**CITY OF WEST DES MOINES
STAFF REPORT COMMUNICATION**

ITEM: Microsoft DSM 14, 1475 SE Maffitt Lake Rd – Approve Major Modification to Site Plan for a site logistics plan for construction of Microsoft Data Center buildings – Microsoft Corporation – MaM-005636-2022

Resolution: Approval of Major Modification to Site Plan

DSM 14 SITE LOGISTICS OVERALL SITE PLAN

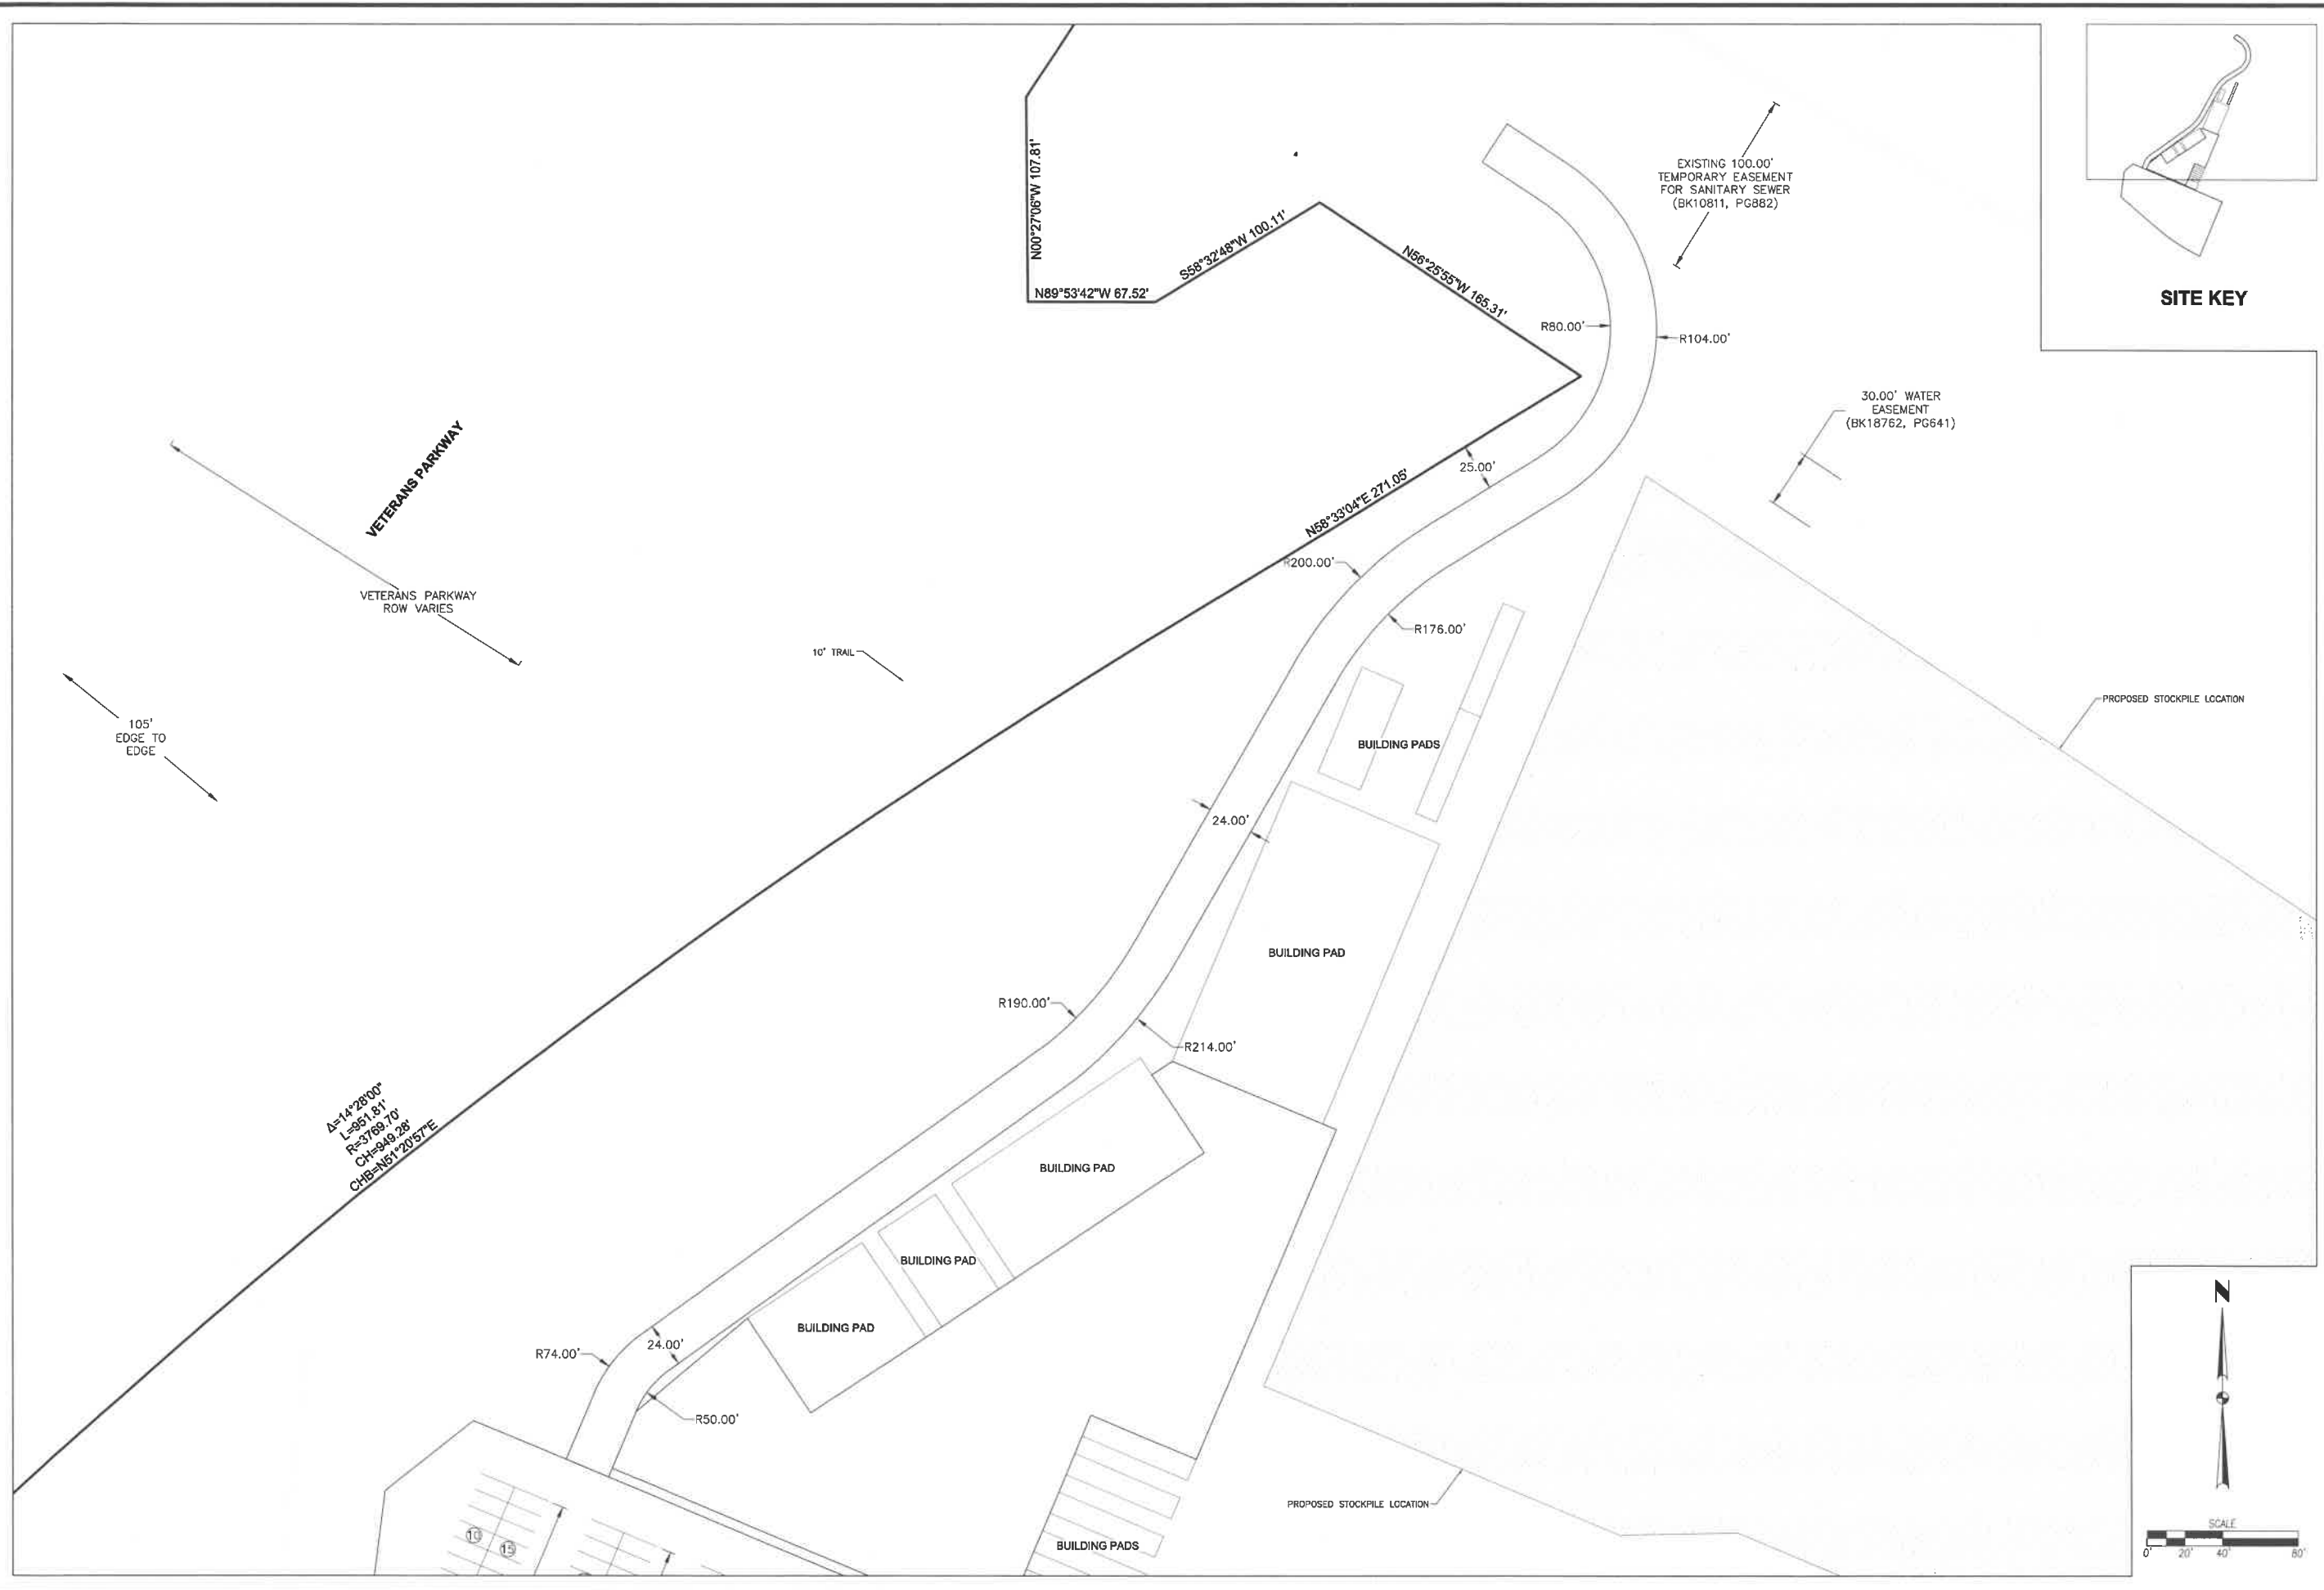
- **Key Development Aspects:**
 1. **Temporary Parking Lot:** A temporary asphalt parking lot is proposed on the southwest corner of this site. This parking lot will be used by construction workers during site construction. The parking lot will be removed after completion of the entire site. Staff recommends a condition of approval that this be completed within sixty (60) days of completion of the entire site development.

2. **Topsoil Stockpile:** The site plans submitted for this Major Modification include two topsoil stockpile areas east of the proposed temporary tent/trailer locations. This has been reviewed by Engineering Services with no concerns expressed.

Recommendation: Approve the Major Modification to Site Plan request, subject to the applicant meeting all City Code requirements, and the following conditions of approval:

1. The applicant shall obtain tent permits for any tents on the site as required by the West Des Moines Fire Department.
2. The applicant agreeing that the tents, trailers, and temporary parking lot shall be removed within sixty (60) days upon completion of the entire site development. Additionally, the tents and trailers shall be removed from the site should construction activities on site cease for a period of six months. The temporary parking lot and associated driveways shall be removed entirely and the area re-graded and seeded.
